**IMPERIAL METALS CORPORATION
MT. POLLEY PROJECT**

**RESPONSE TO REVIEW COMMENTS
ON TAILINGS EMBANKMENT DESIGN
(REF. NO. 1625/6)**

JANUARY 25, 1996

FIGURE 3

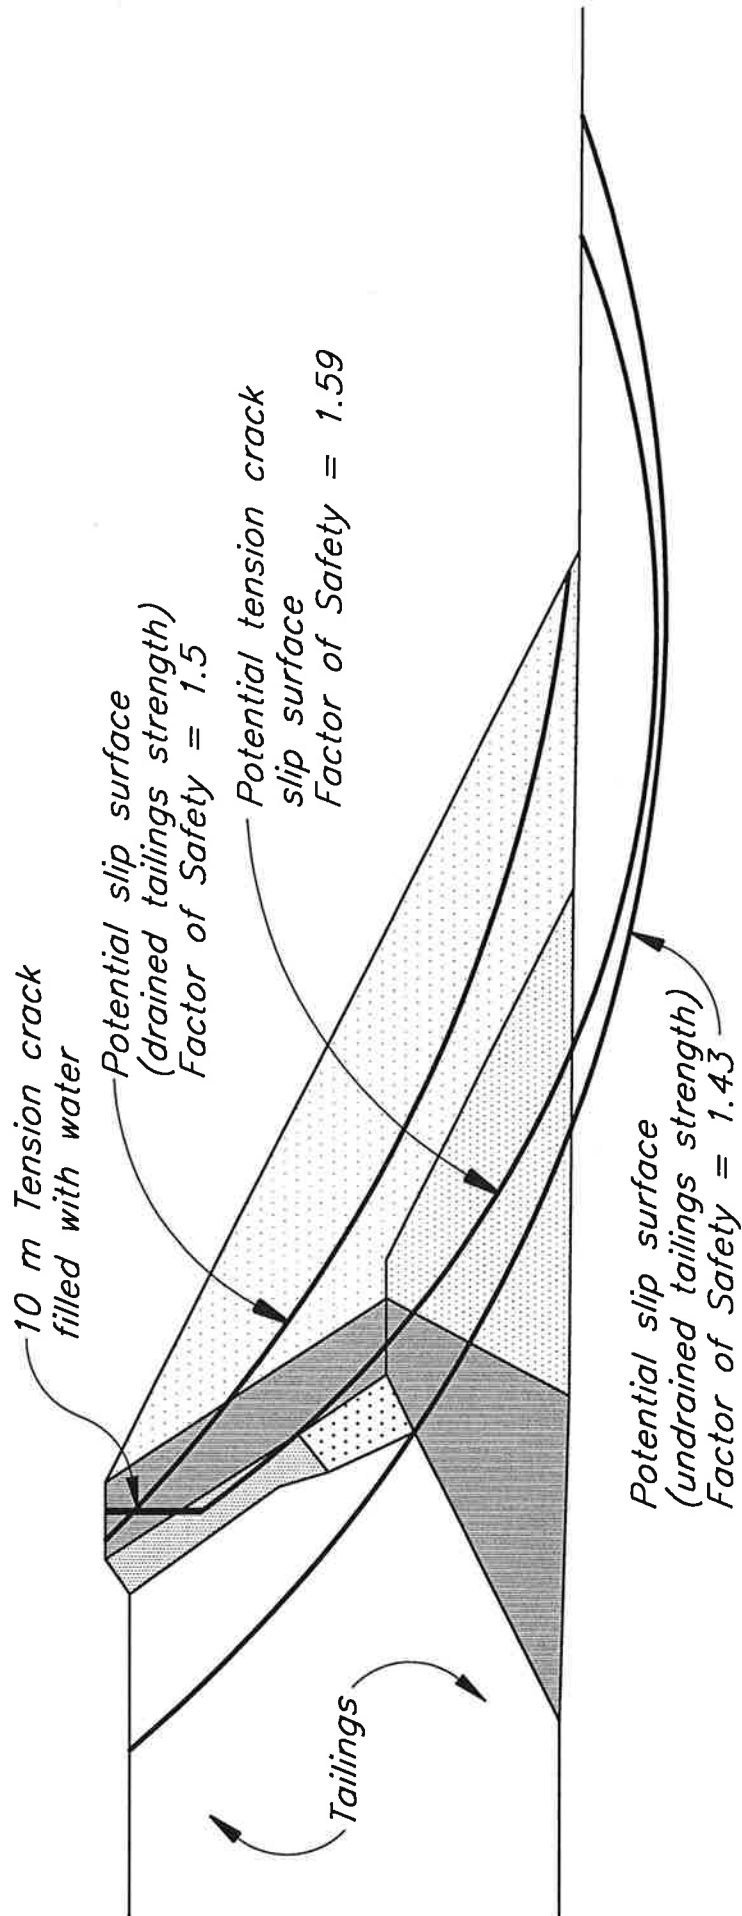
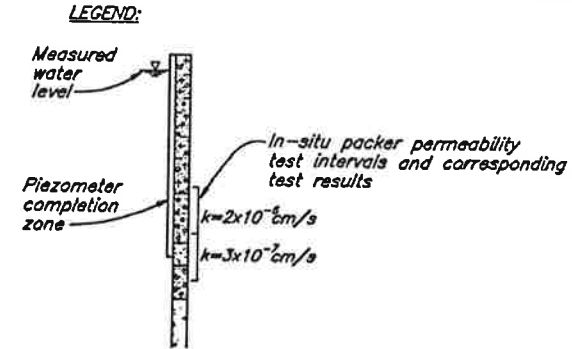
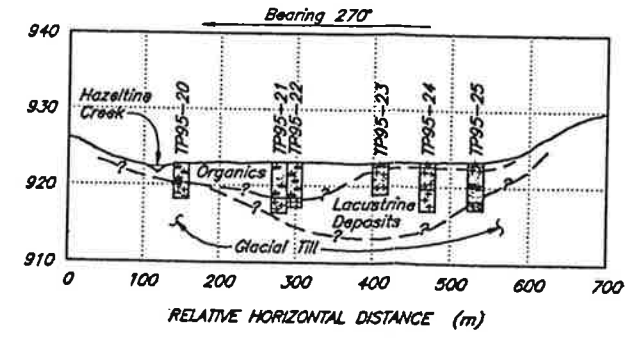
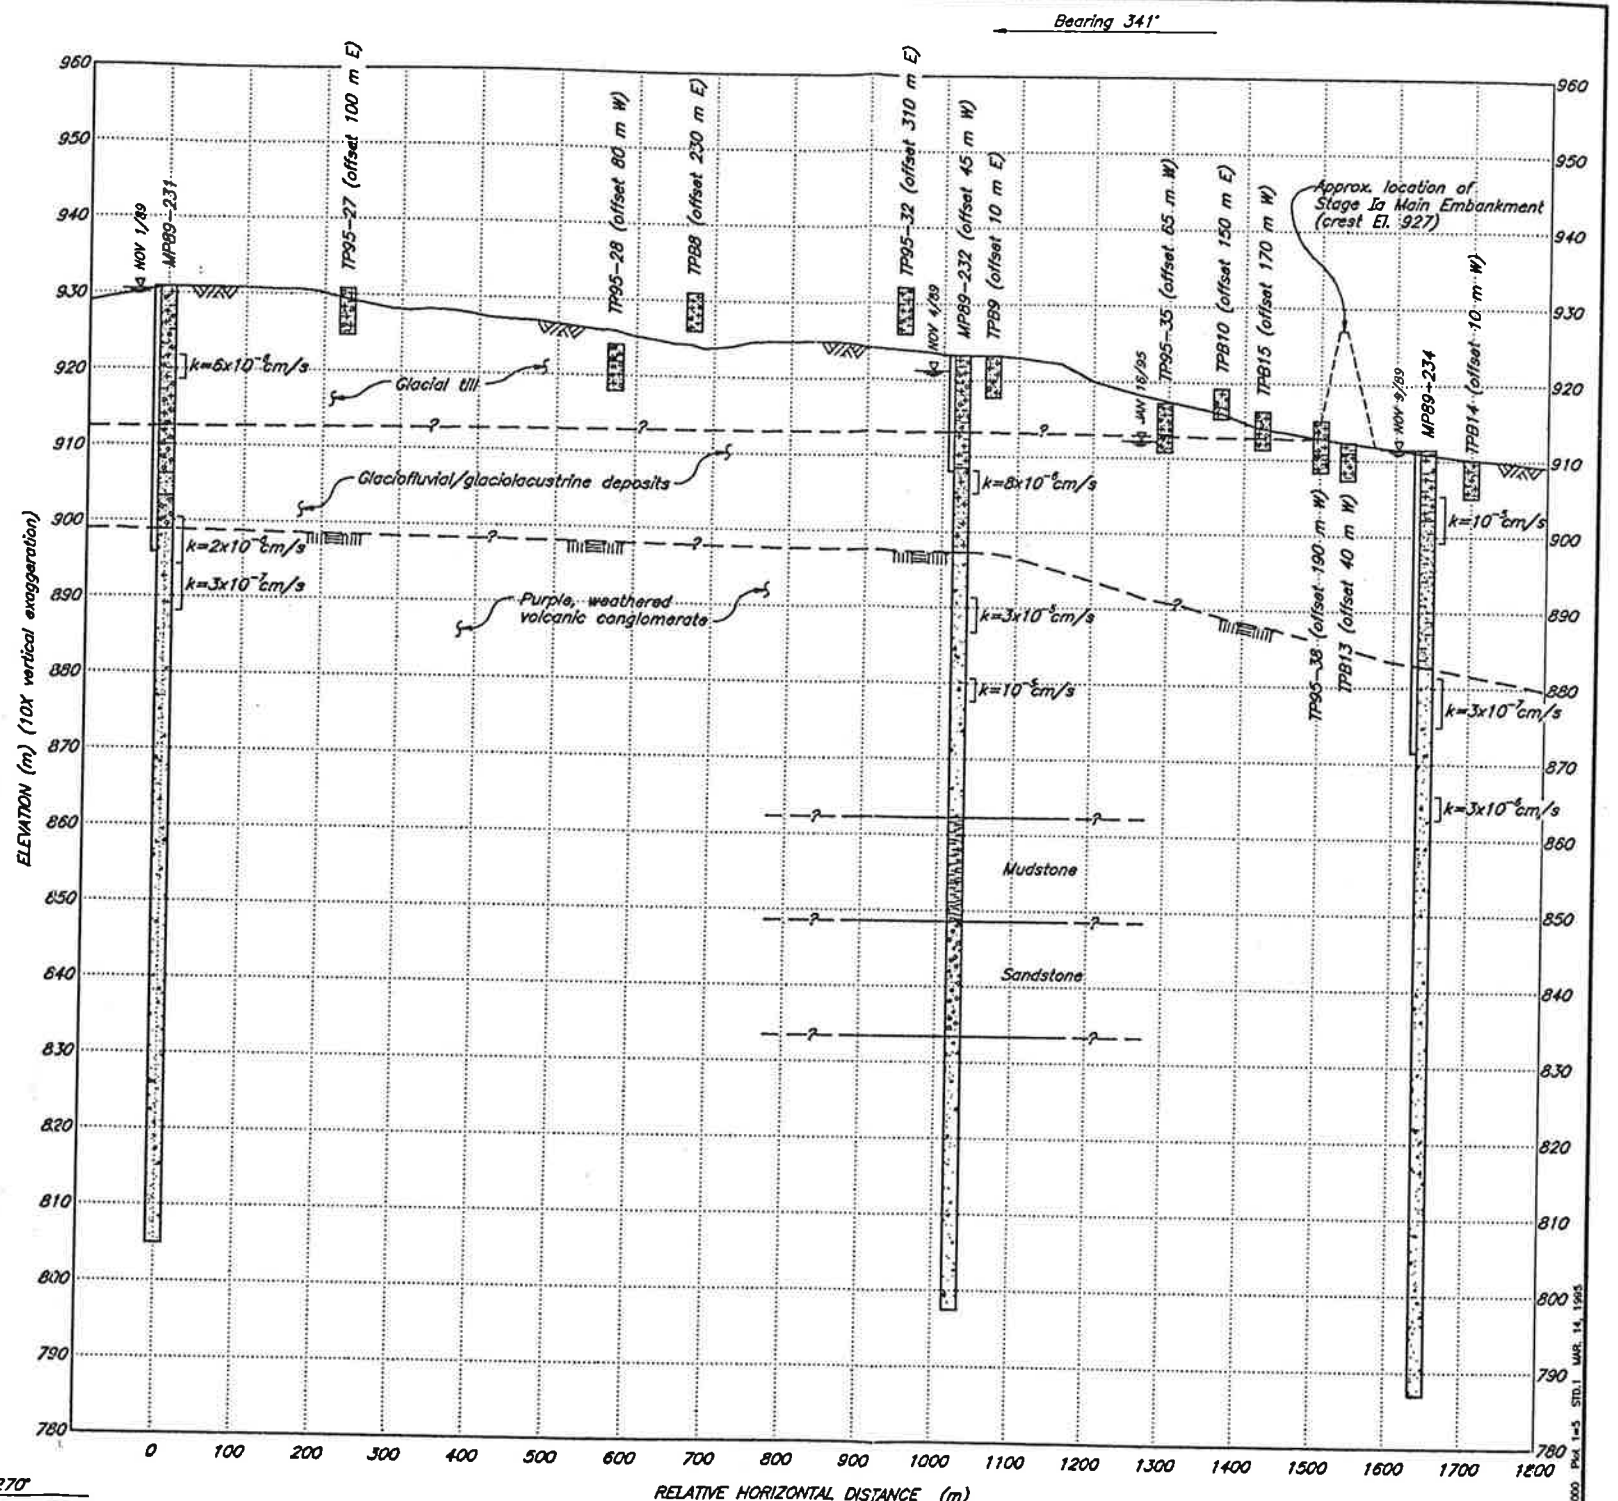
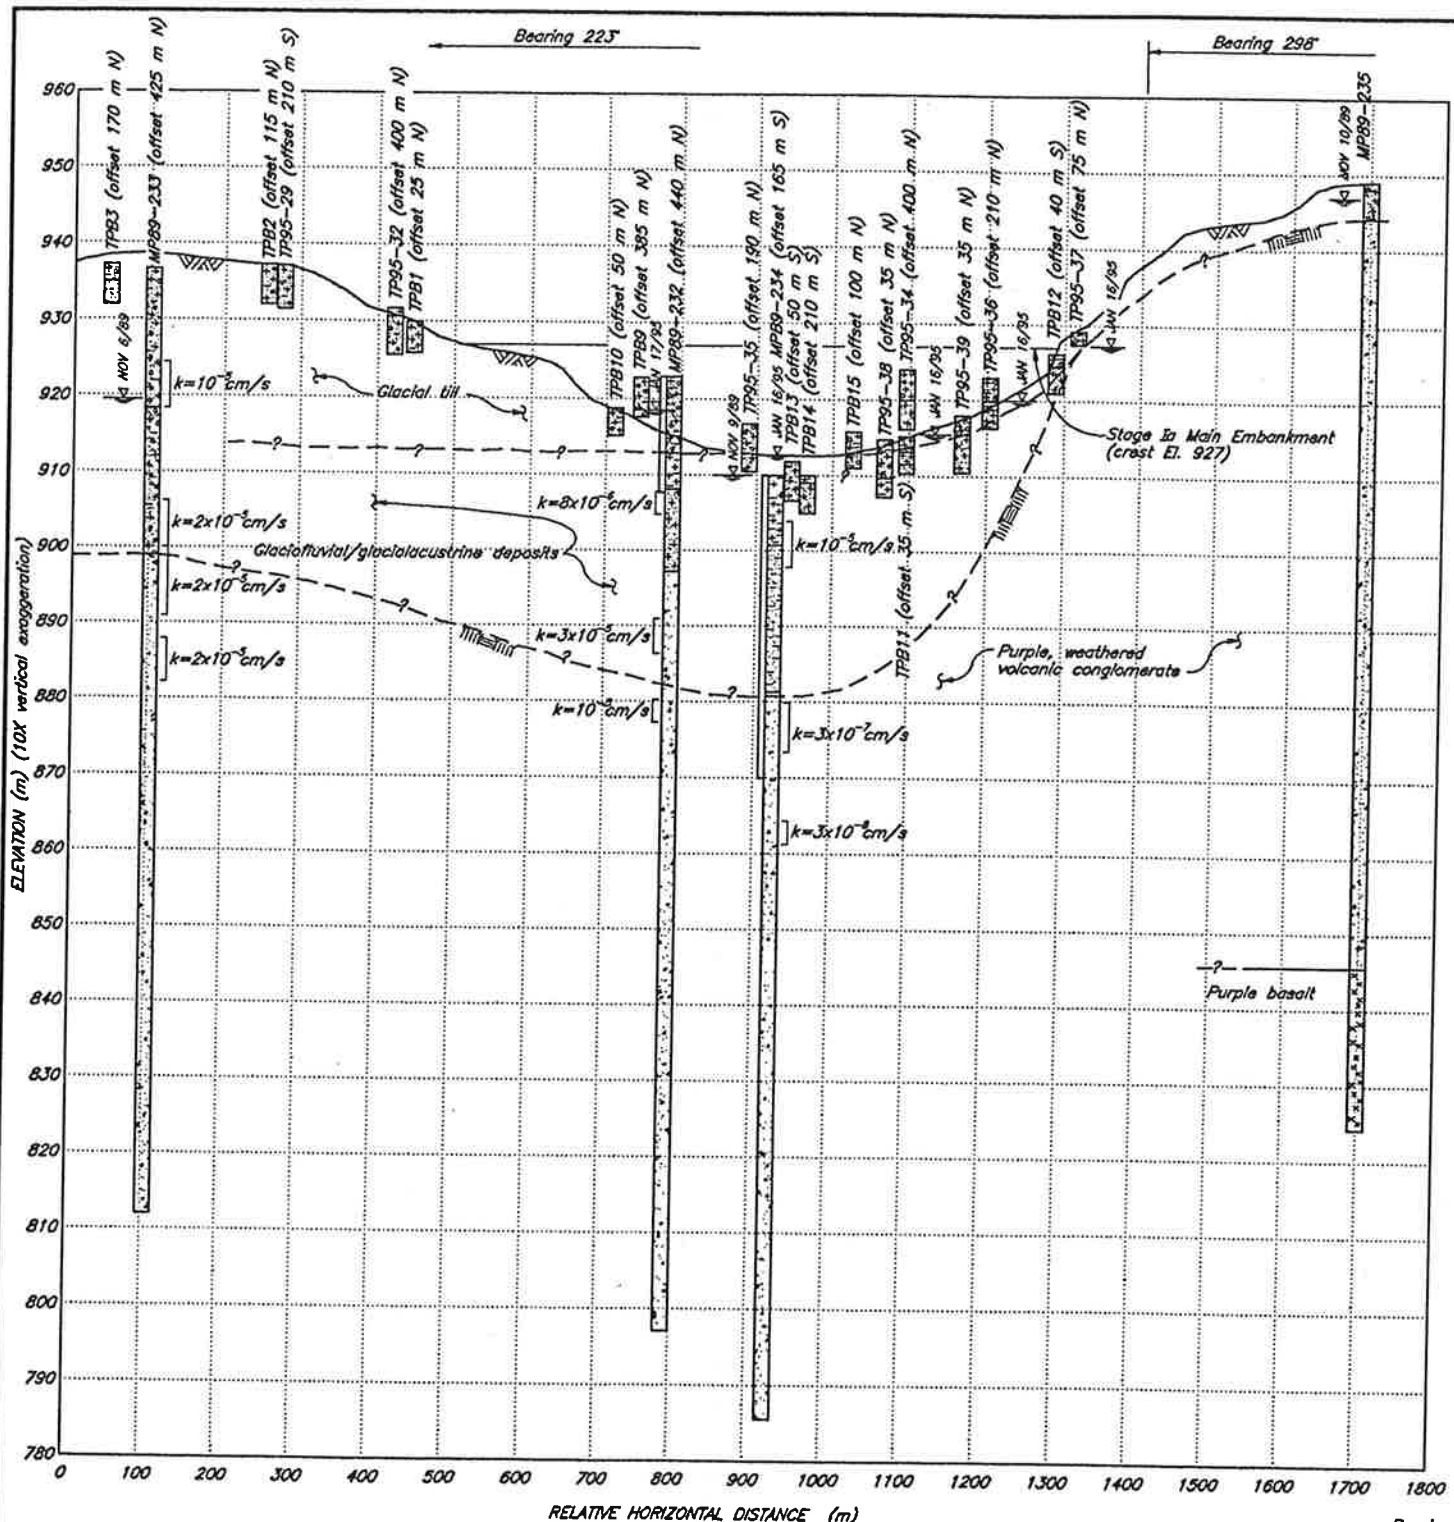
The design proposed entails some of the compacted main dam to be constructed over loose to medium dense tailings. With this design variability in consolidation characteristics would be expected. This could lead to tension cracks near the top of the main dam and generally parallel to C.L. Stability analysis should allow for 10 m deep tension cracks filled with water.

Based on our experience with similar construction methods and comparable tailings materials, it is highly unlikely that 10 m deep tension cracks can develop along the crest of the embankment. However, as suggested by Mr. Brawner, stability analyses have been conducted for a 10 m deep tension crack filled with water, as shown on Figure 3. The factor of safety for the water filled tension crack is higher than for the previously reported stability analyses. Therefore, the previously reported minimum factors of safety for the tailings embankment are unchanged even if a 10 m water filled tension crack occurs.

An upstream slip surface for a 10 m water filled tension crack was also evaluated. The results showed that this case is also not critical as the factor of safety is well in excess of 1.5.

DATE: MARCH 14, 1995
SCALE: AS SHOWN
DRG. NO.: 1623.103
REV. 0

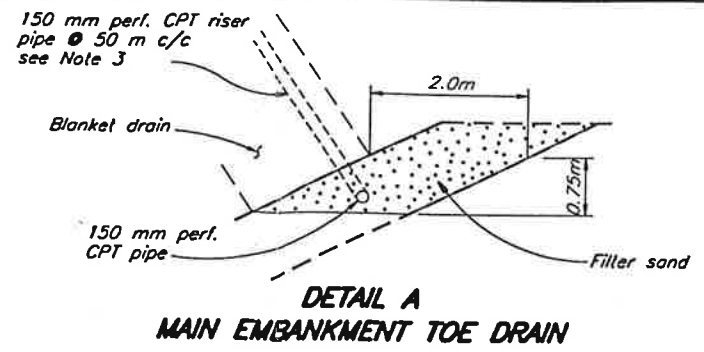
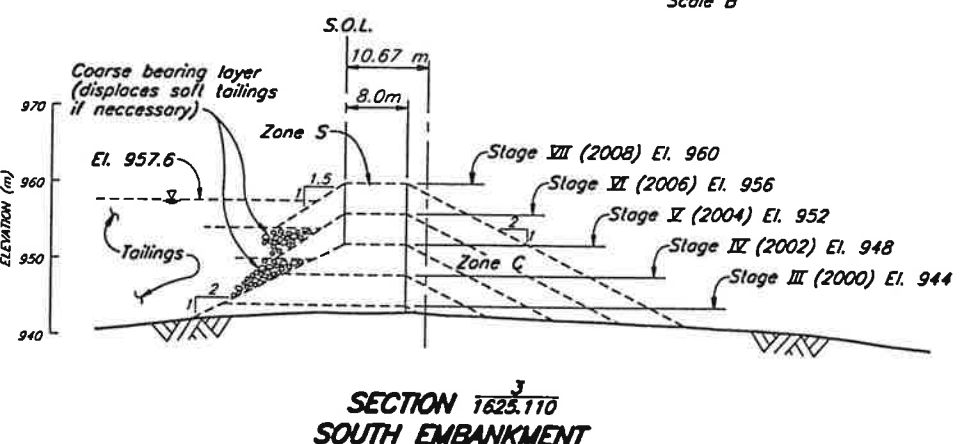
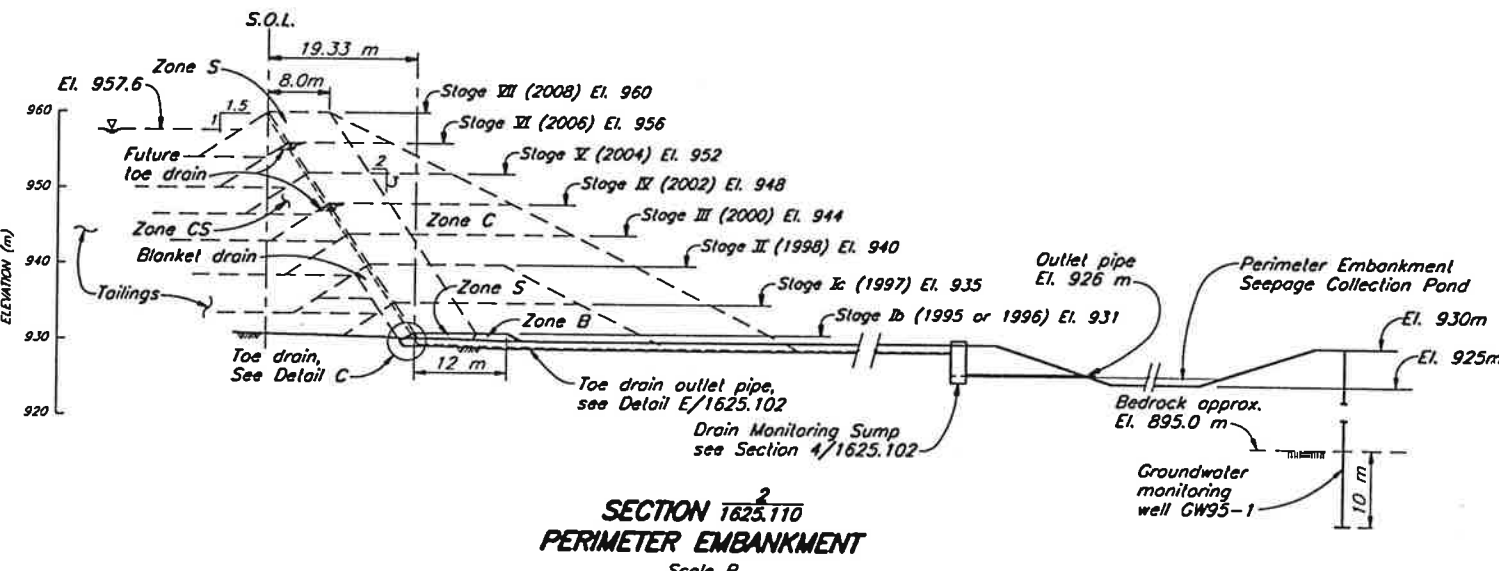
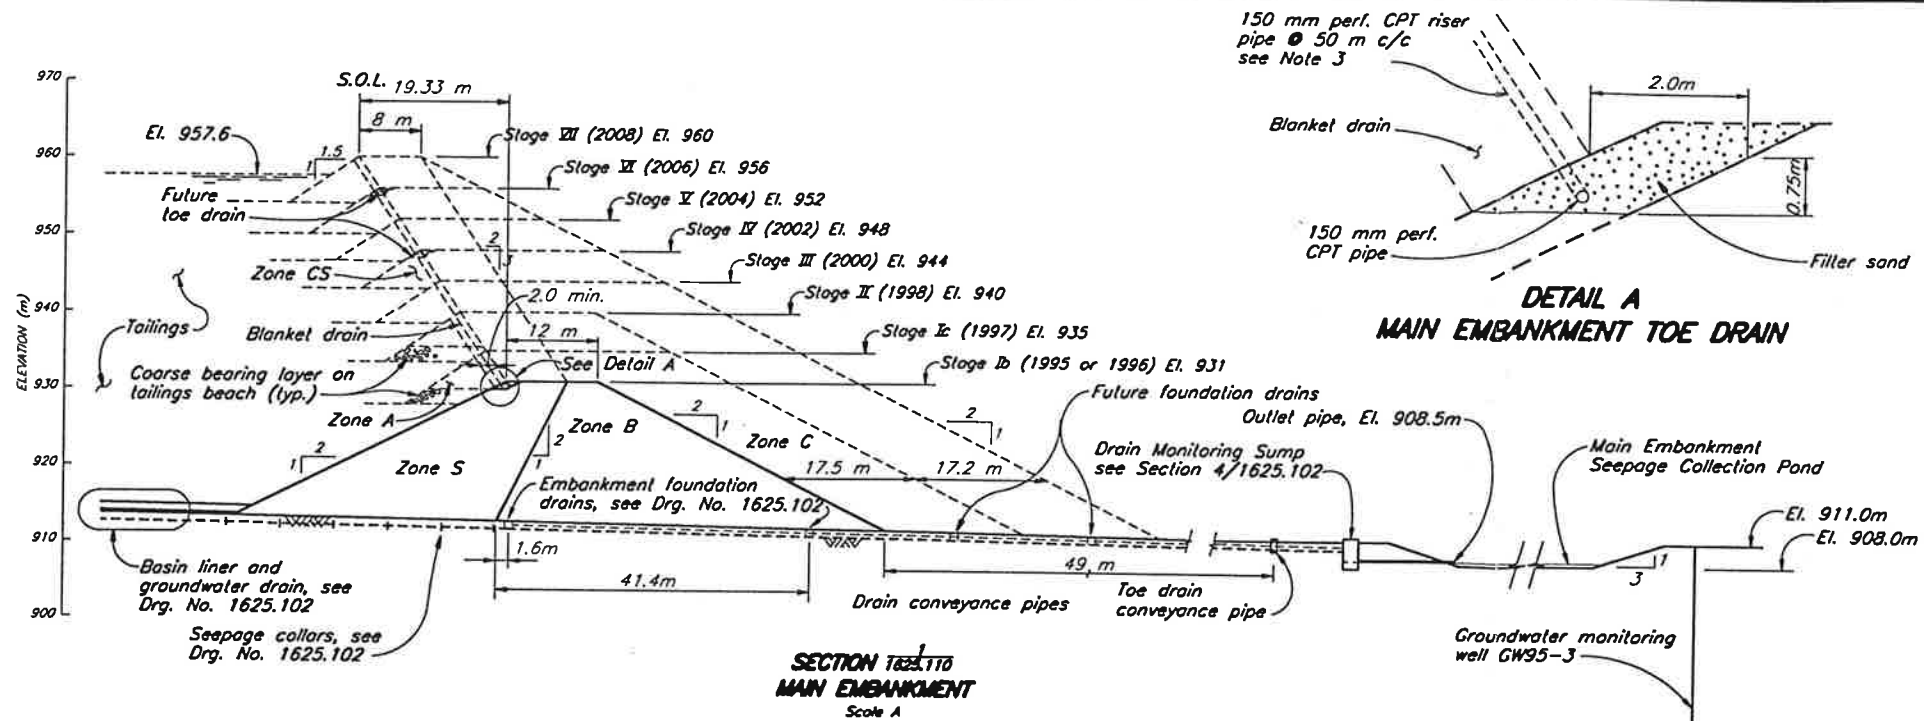
If the liner is placed it is suggested that a seepage cut-off be excavated and backfilled through the sediments near the upstream toe of the main embankment.

The nature and distribution of the geologic units, as described above and as shown on Drawing No. 1623.103, illustrate that it would be extremely difficult to construct a seepage cut-off at the upstream toe of the Main Embankment. In order for the cut-off wall to be effective, it must be extended to low permeability materials both vertically and laterally or else the seepage losses will merely be redirected to a different direction. Therefore, the seepage cut-off would have to be extended completely along the West Embankment. The seepage cut-off wall would be extremely difficult to construct and it is unlikely that it would provide any additional benefit and could actually result in a less efficient seepage control measures than the currently designed system.
